**Goddard Space Flight Center  
Wallops Flight Facility  
Wallops Island, VA 23337**

## Meeting Minutes

Shoreline Restoration and Infrastructure Protection Program EIS

### Shoal A Volume Analysis 3D Map

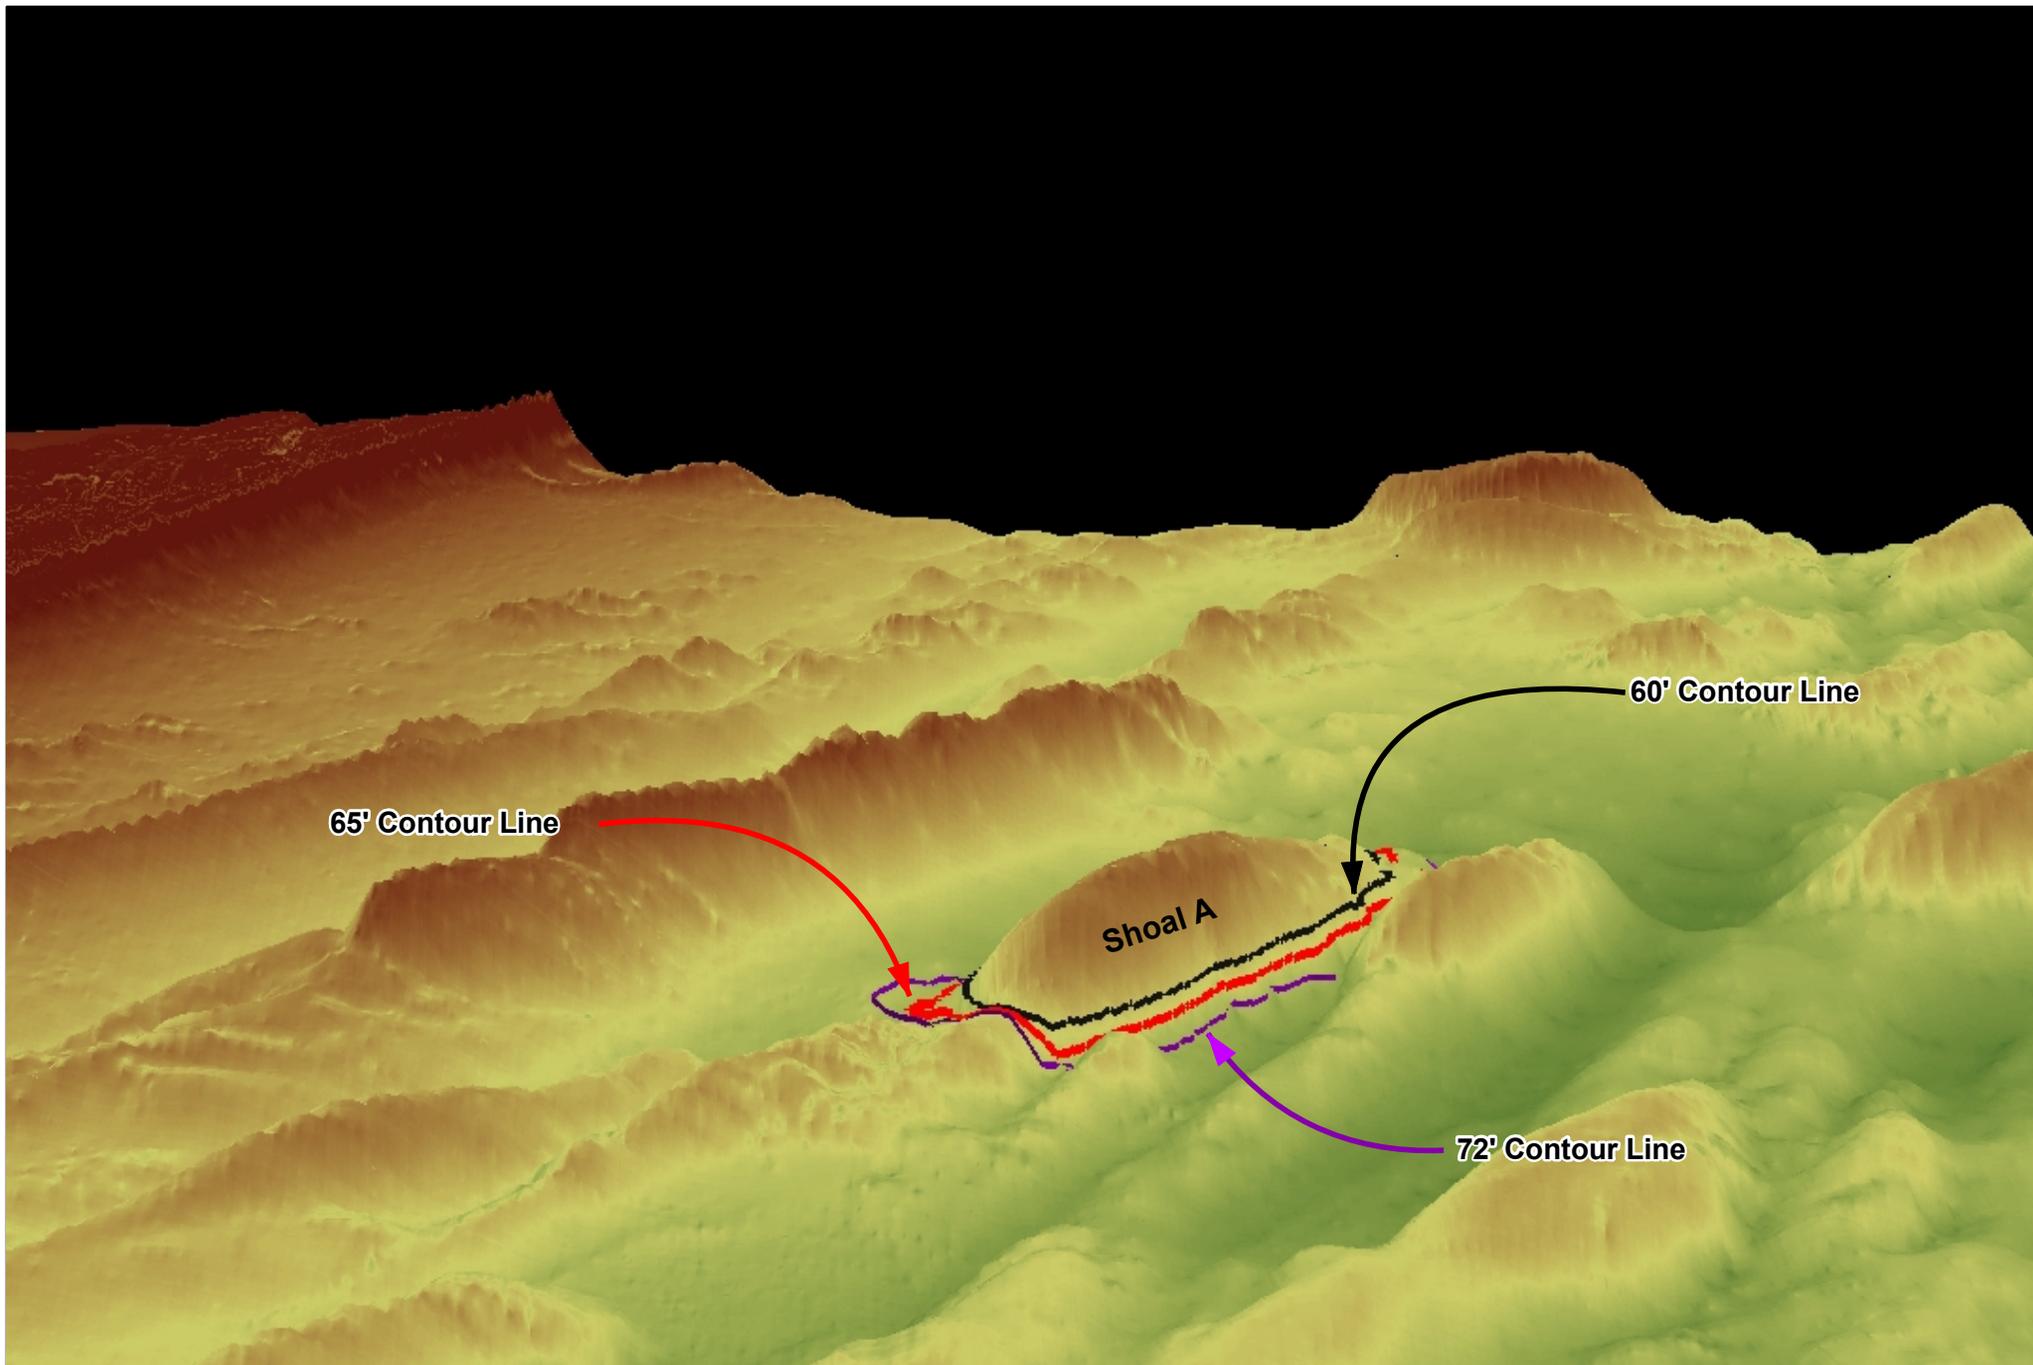
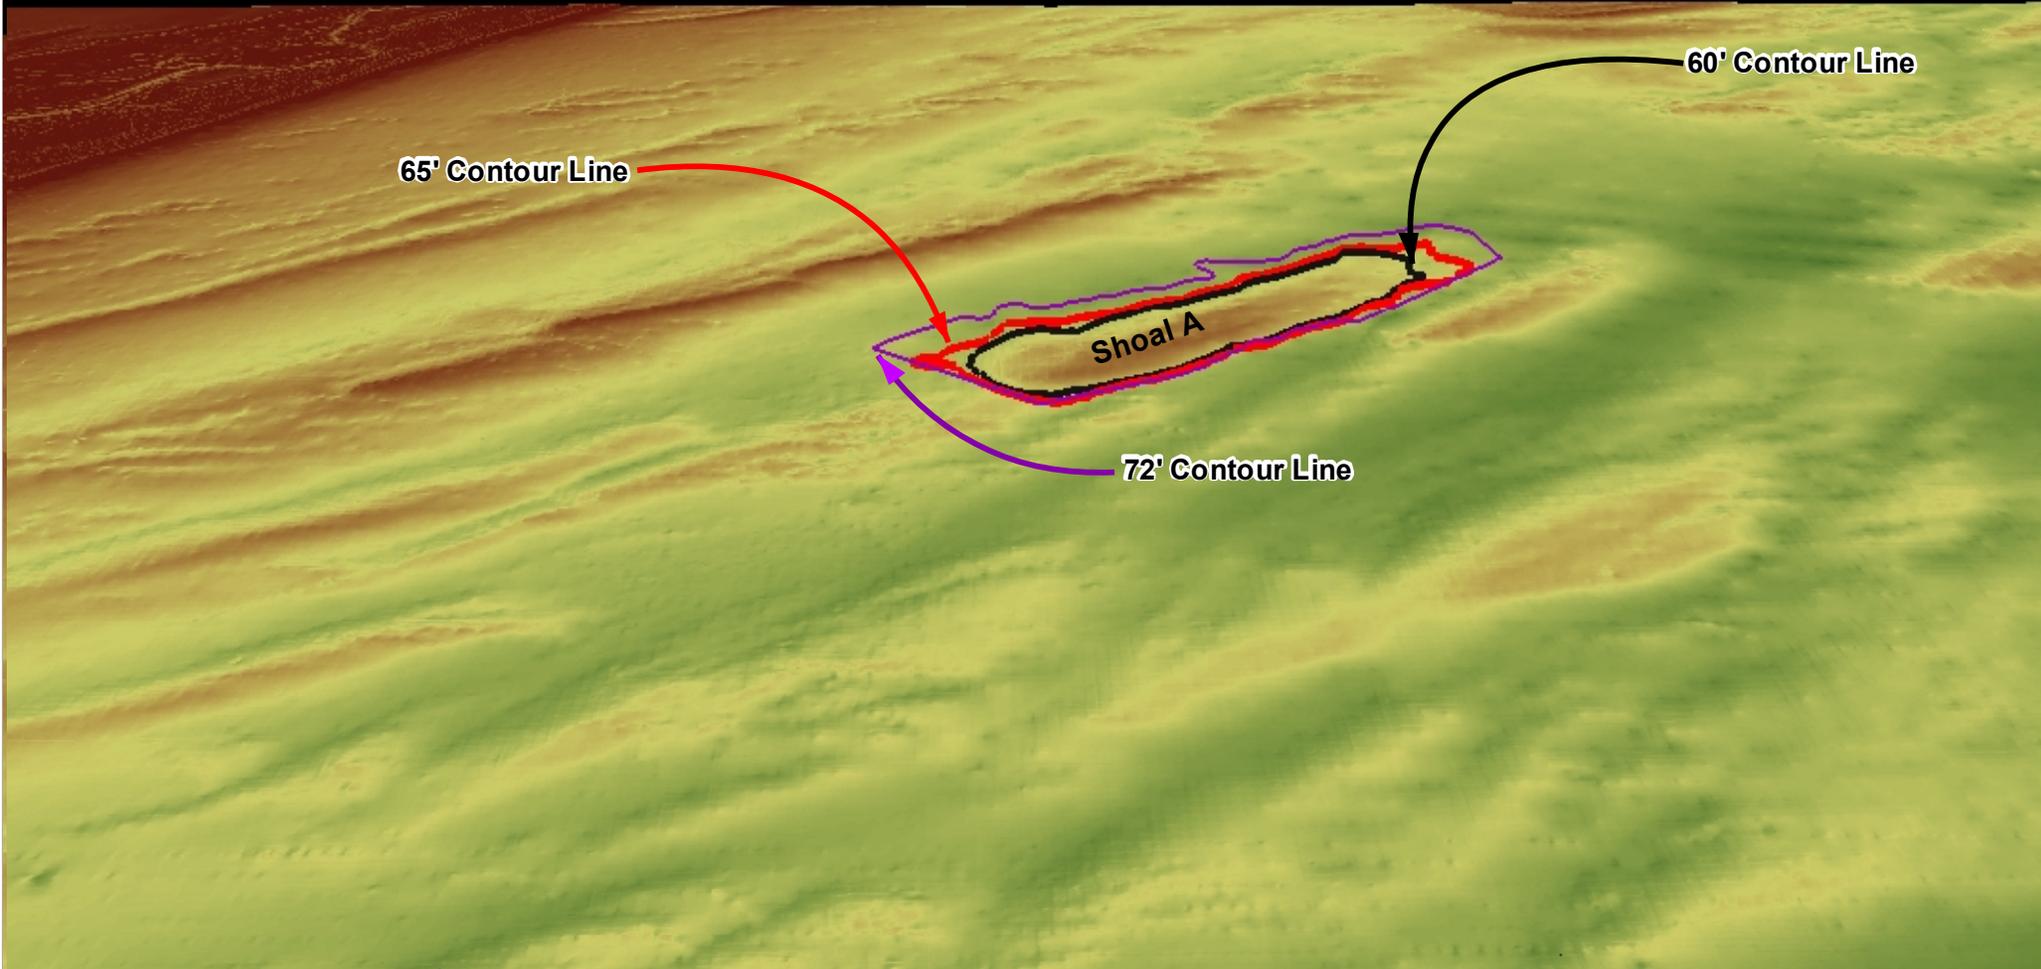
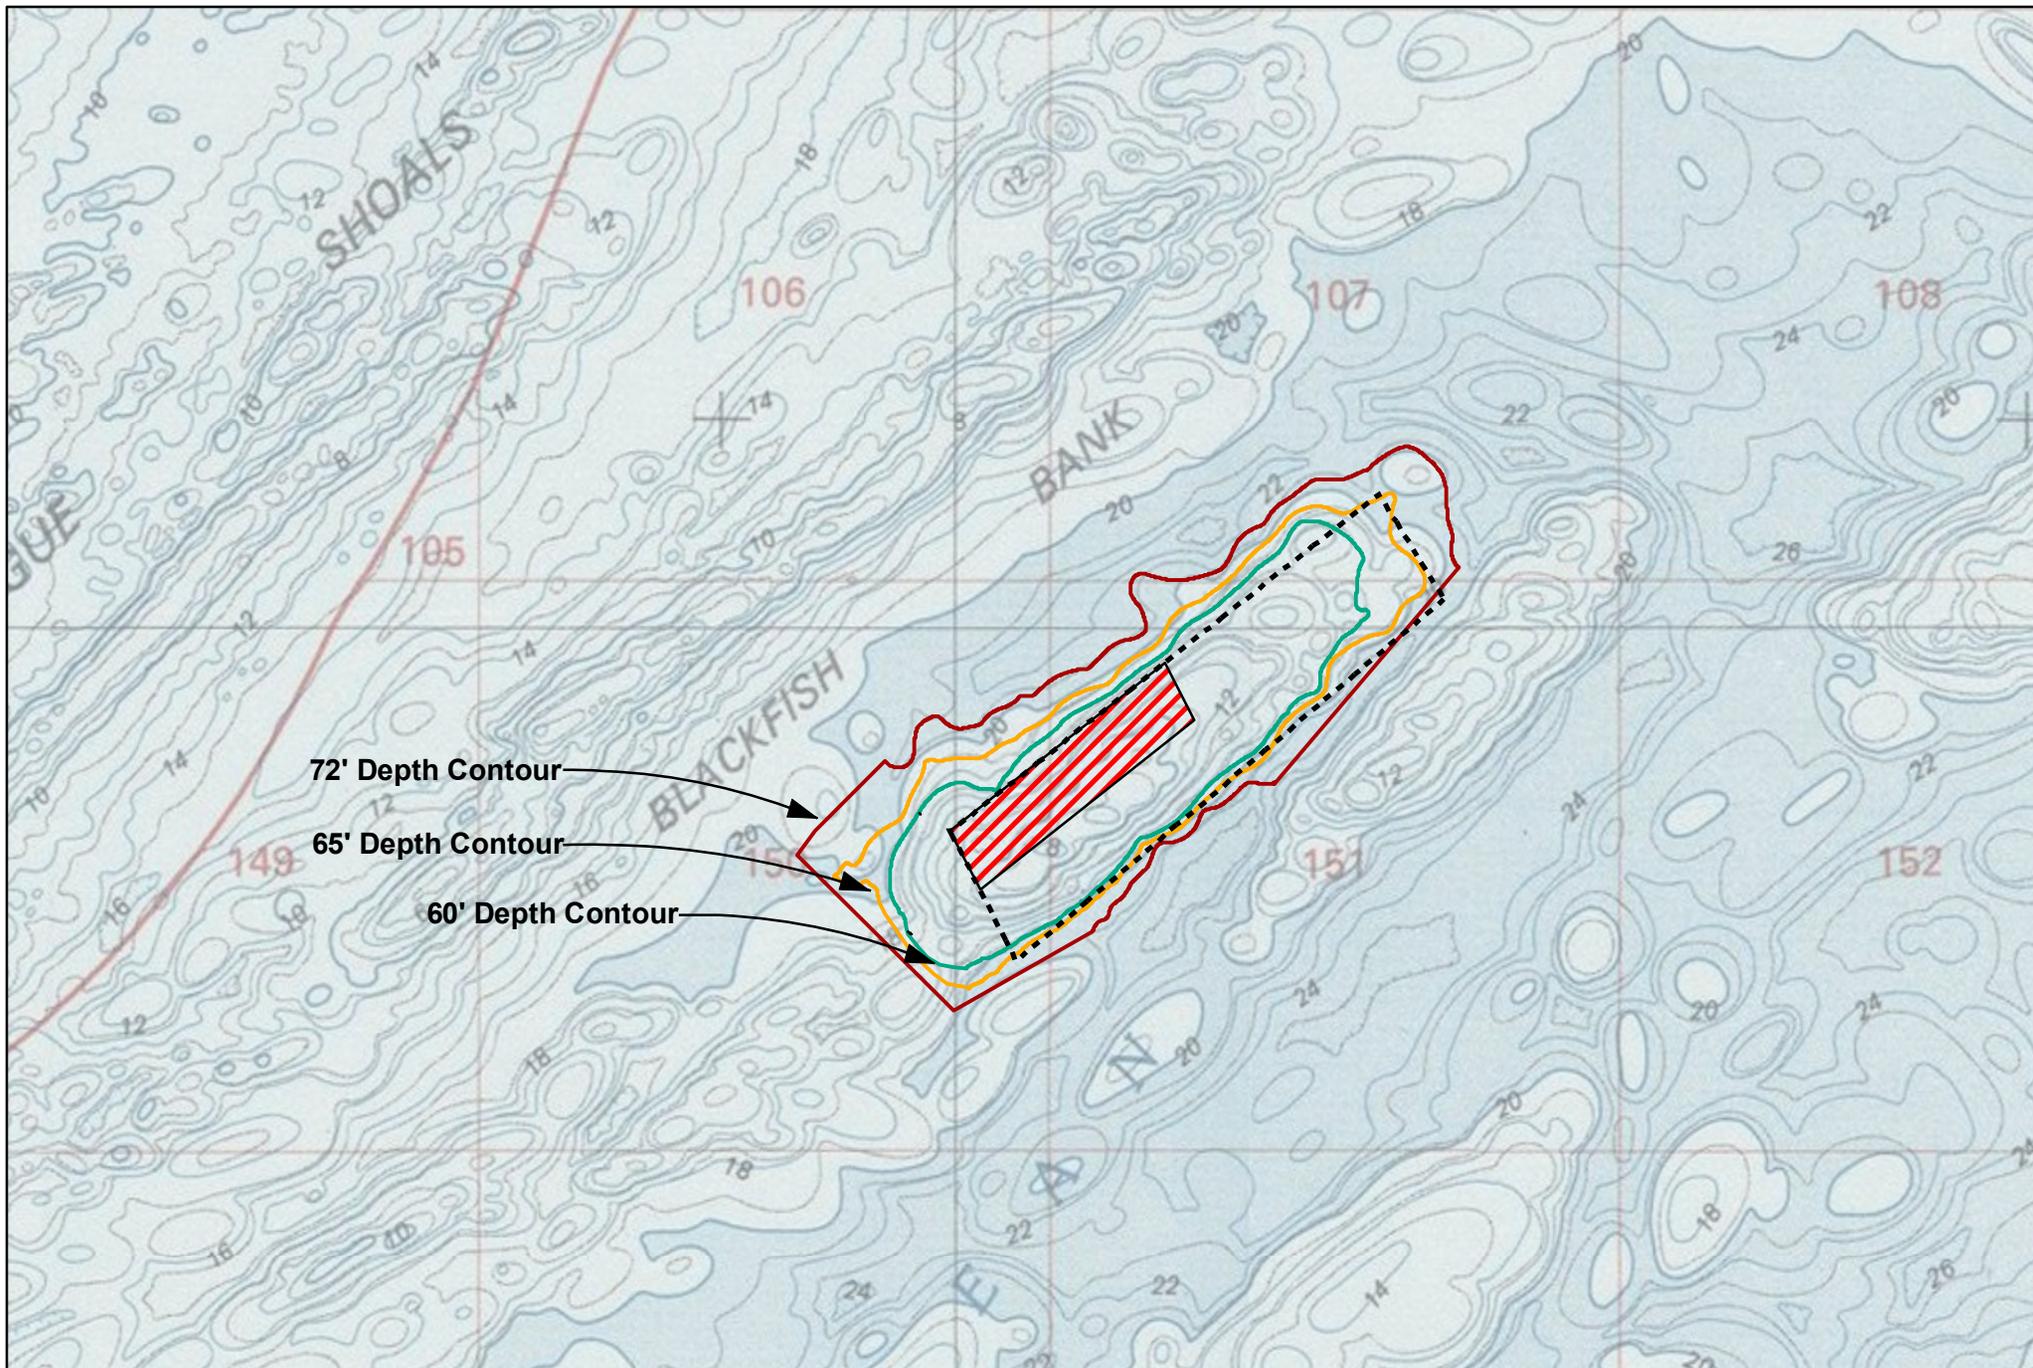
Another information request also came to mind; if we were to recommend that only 5% of Shoal A total volume be used for this project (i.e., 2 MCY), and the remainder of sand for the initial phase of the project were to come from Shoal B (1.2 MCY), would this reduce cost, and provide more sand under your cost ceiling?

**Proposed Depth of Cut:** We have calculated that we can remove the needed volume of material from Shoal A with a 2-meter cut from within the southwest quadrant depicted on the map entitled "Shoal A Volume Analysis Map."

**Project Impacts:** If we were to obtain all initial fill sand from Shoal A, we would be short approximately 310,000 CY of fill. If we were to remove 2.0 MCY from Shoal A and 1.2 MCY from Shoal B, we would be short approximately 115,000 CY of fill. Clearly, these are substantial impacts to our proposed project and design template.

**Proposed Depth of Cut:** We have calculated that we can remove the needed volume of material from Shoal A with a 2-meter cut from within the southwest quadrant depicted on the map entitled "Shoal A Volume Analysis Map."

**Project Impacts:** If we were to obtain all initial fill sand from Shoal A, we would be short approximately 310,000 CY of fill. If we were to remove 2.0 MCY from Shoal A and 1.2 MCY from Shoal B, we would be short approximately 115,000 CY of fill. Clearly, these are substantial impacts to our proposed project and design template.

# Profile 1

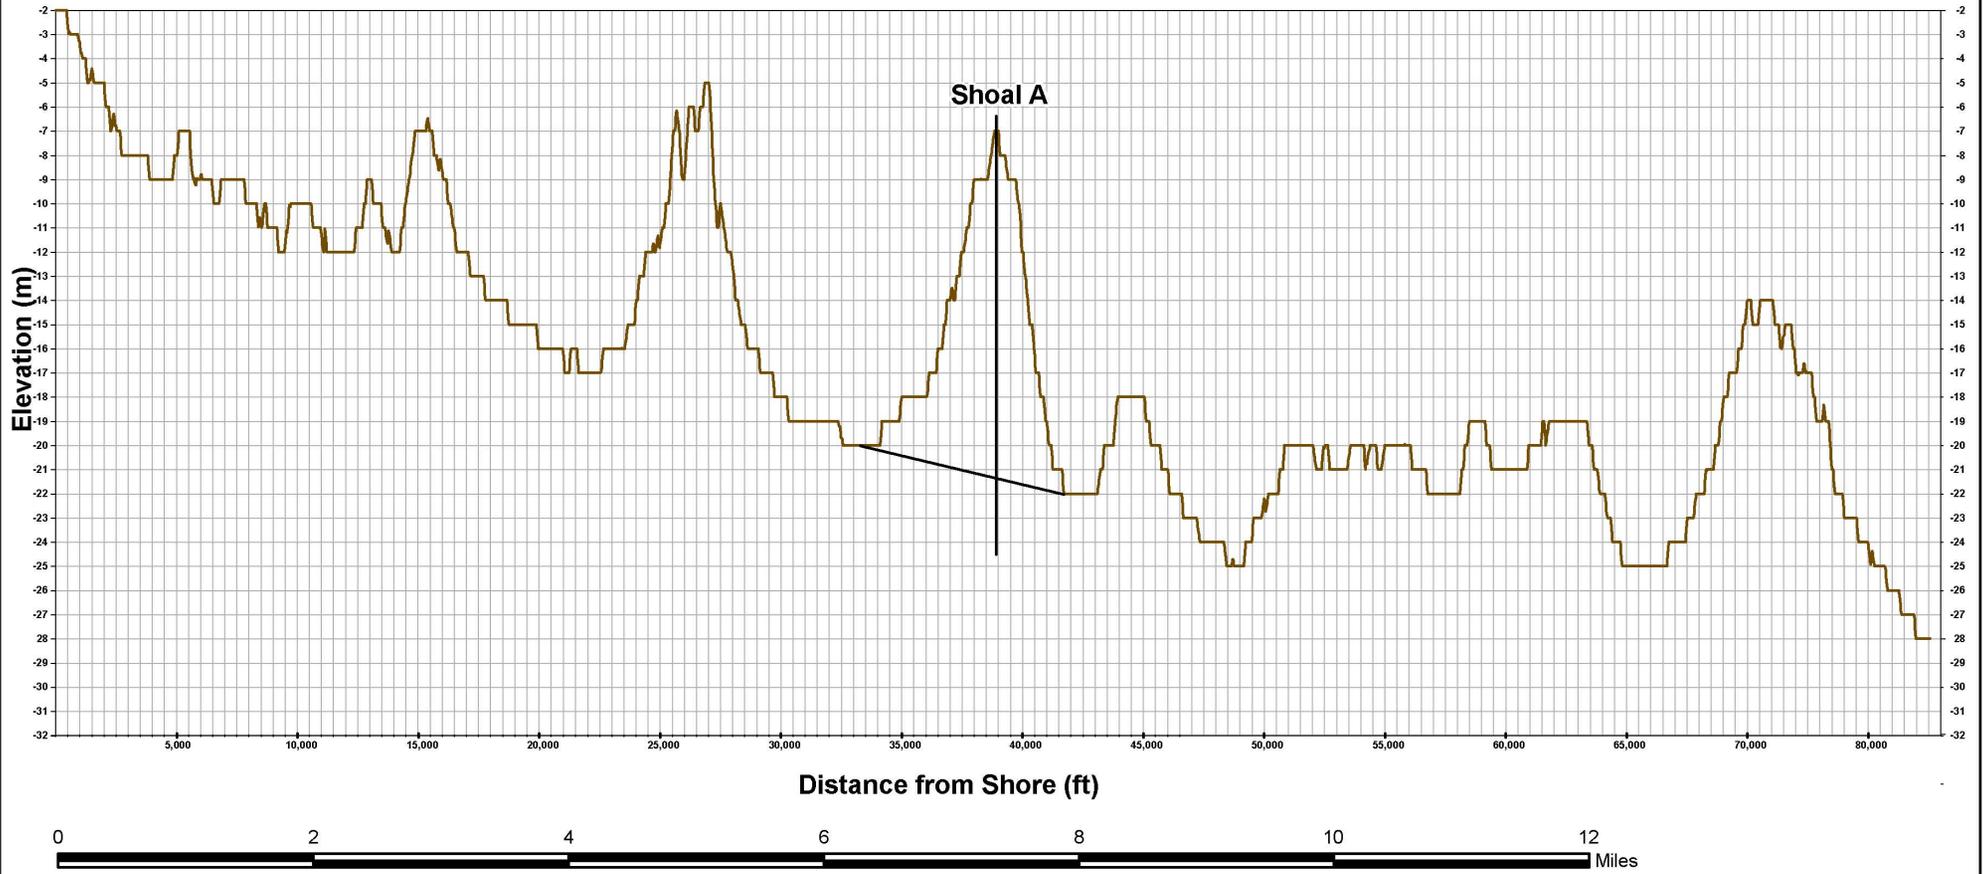
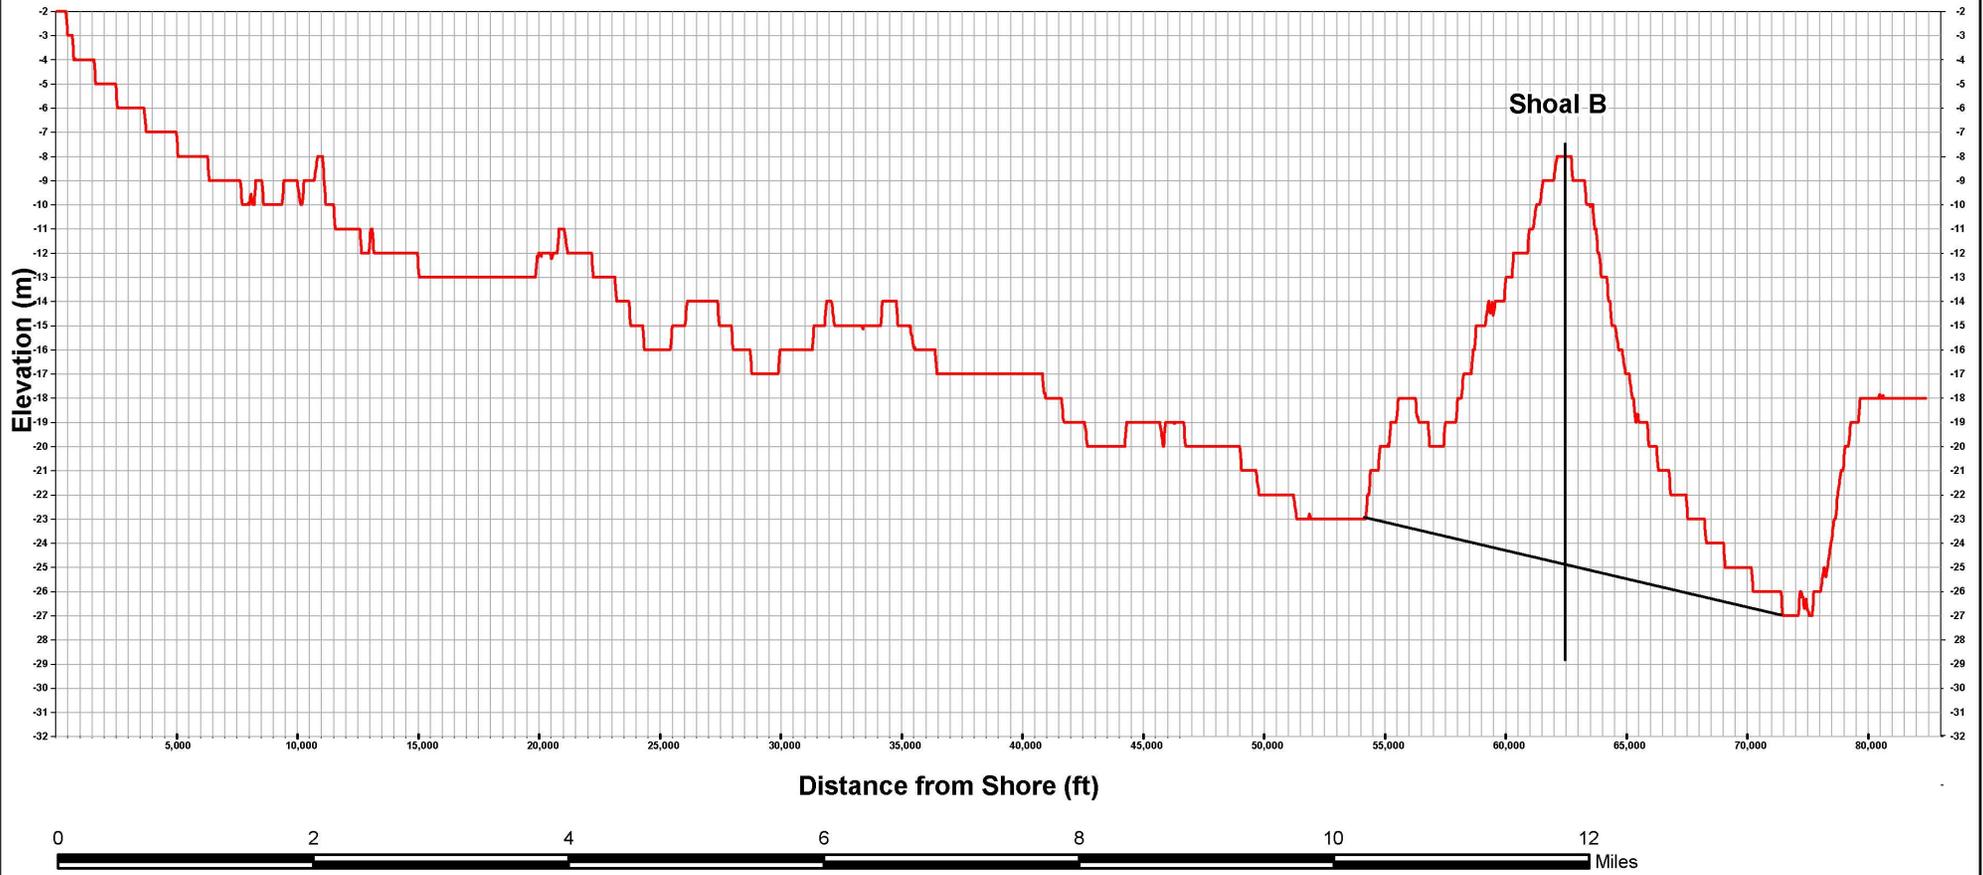
**Response:** Using the shoal cross-sections presented in our June 2010 EFH Conservation Recommendation response letter, both SRIPP Shoals A and B have Relative Shoal Heights (RSHs) of approximately 0.68. Lowering either shoal by 2 meters yields RSHs of 0.59 and 0.60, respectively. Removal of an additional meter (totaling 3 m) would still yield values above the 0.5 RSH threshold identified in the referenced report.
